Appl. No. 10/773,525 Amdt. dated Reply to Office action of November 3, 2006

**Amendments to the Drawings:**

REMARKS/ARGUMENTS

FIG. 5a - CHANGED  
5705a

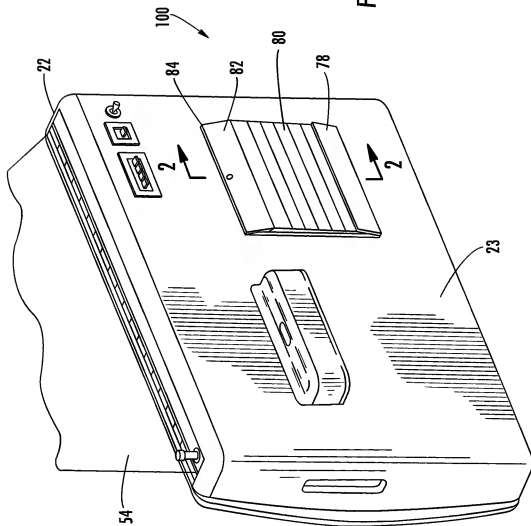
The attached sheets of drawings includes changes to Fig. 5, 5C and 5D. These sheets, which includes Figs. 5A, 5B and 5C, replace the original sheets including Figs. 5, 5c and 5d.

In the drawings, Figures 5, 5C and 5D have been amended to be identified as Figures 5A, 5B and 5C respectively to comply with the requirements of 37 CFR 1.84.
